TRANS/WP.29/GRSP/2001/13
2 April 2001

World Forum for Harmonization of Vehicle Regulations (WP.29)

PROPOSAL FOR DRAFT AMENDMENTS TO REGULATION No. 44

(Child restraints)

TYPE APPROVAL SCHEME (FLOW CHART ISO 9002 1994)

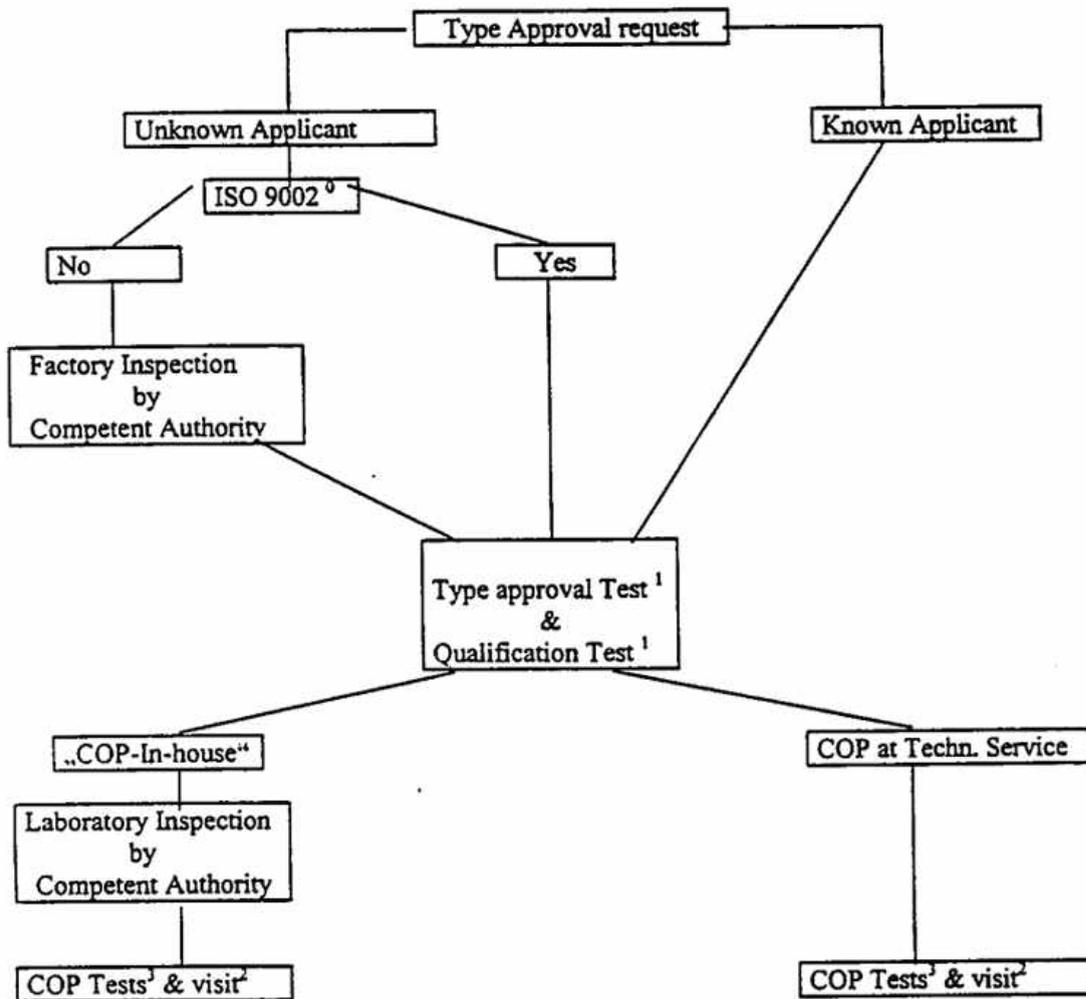
Insert a new annex 16, to read :

"Annex 16

0) or an equivalent standard to this one

1) this tests have to be done at technical service

2) Visit of the manufacturer for inspection and random sampling by the authority or technical service:

a) if there is no ISO 9002: 3 times a year

b) if there is an ISO 9002: 1 time a year

3) tests in accordance to 10.5 annex 17

a) if there is no ISO 9002: of the authority or technical service during the visit of footnote 2 a of the manufacturer between the visits of footnote 2 a

b) if there is an ISO 9002: taken by the manufacturer, procedure checked during visit of footnote 2 b
